73-36
Van Leeuwen Subdivision

APPLICATION FOR SUBDIVISION APPROVAL
Town of New Windsor, Orange County, N.Y.

Re: Lands of W. Leghorn

WATER, SEWER, HIGHWAY REVIEW FORM:

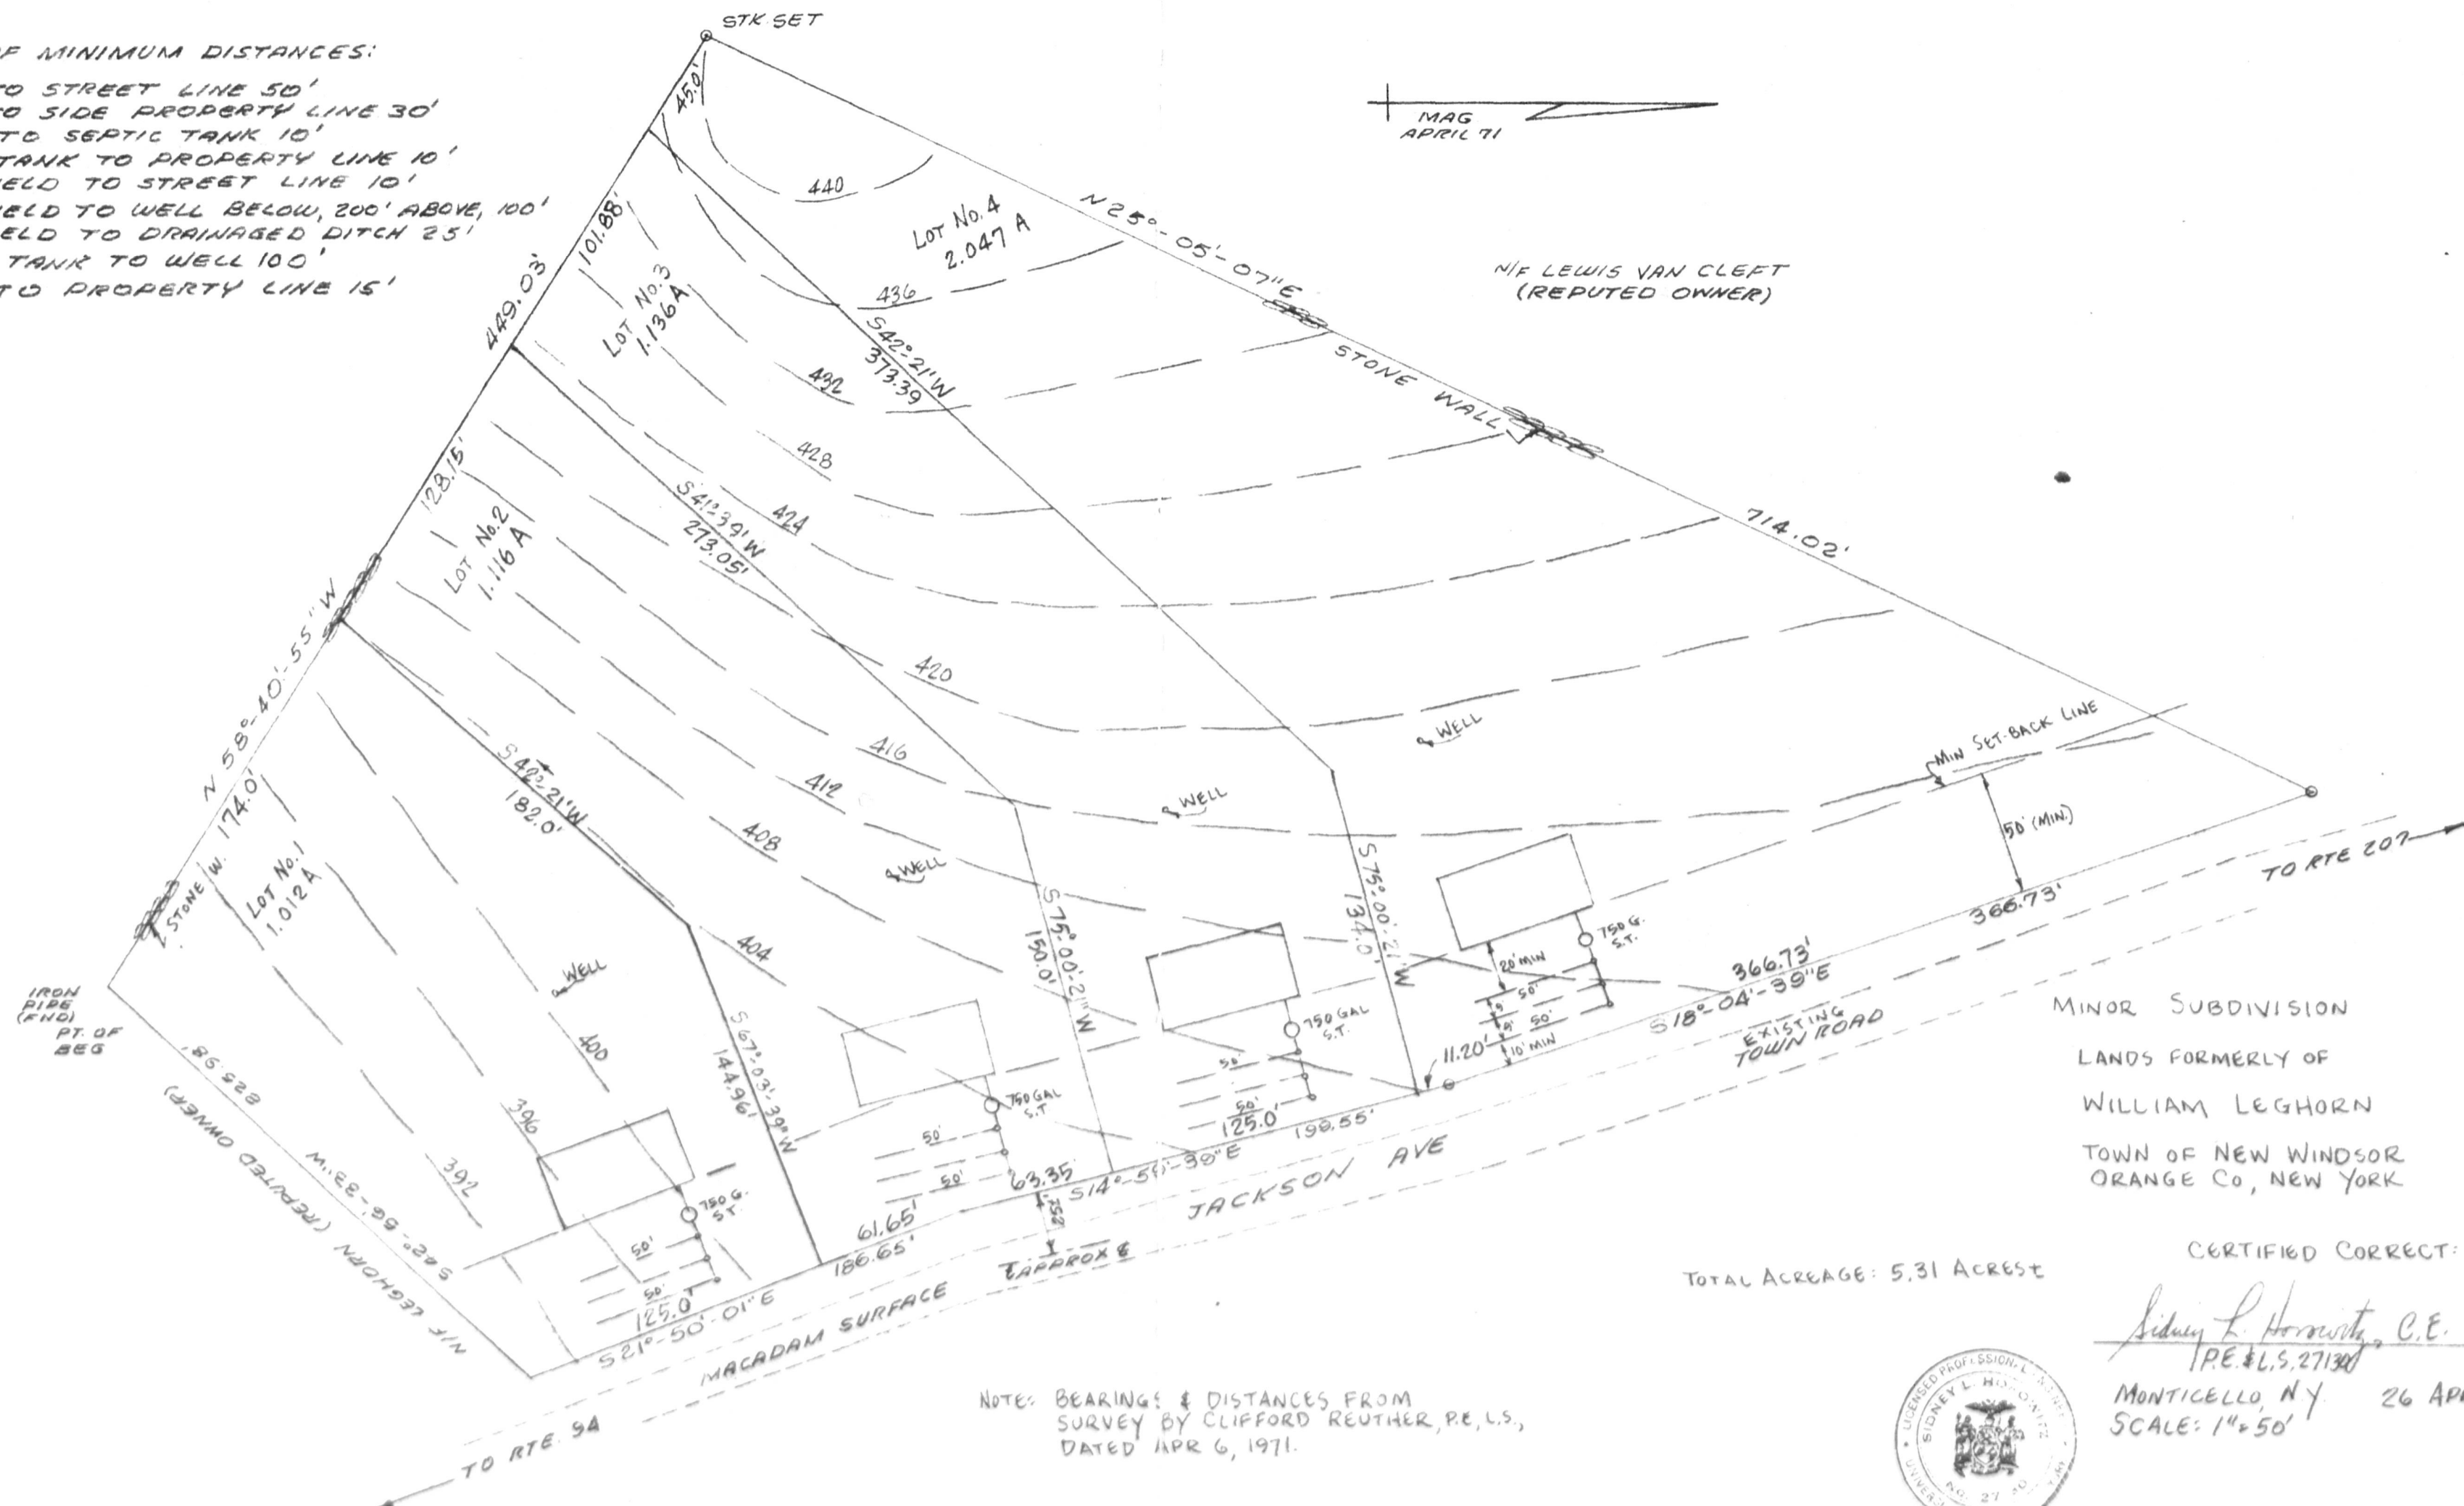
This plan meets all the technical requirements of the subdivision and zoning regulations with the exception of the property zone indication. Percolation is good and if the Sanitary Superintendent approves, the plan may receive final Planning Board approval.

One comment which does not actually affect the plan should be made. The design engineer has schematically indicated all the leach fields running cross-contour while in reality they are placed with the contour.

Submitted maps indicate percolation test has been made, however percolation for each lot should appear on the map.

The size of the septic tank depends on number of bedrooms proposed. A conversation with Mr. Van Leeuwen and myself has indicated that these houses would be 3 bedrooms. The size of the tank (750 gal.) is correct, but the number of bedrooms should appear on the map for future reference.
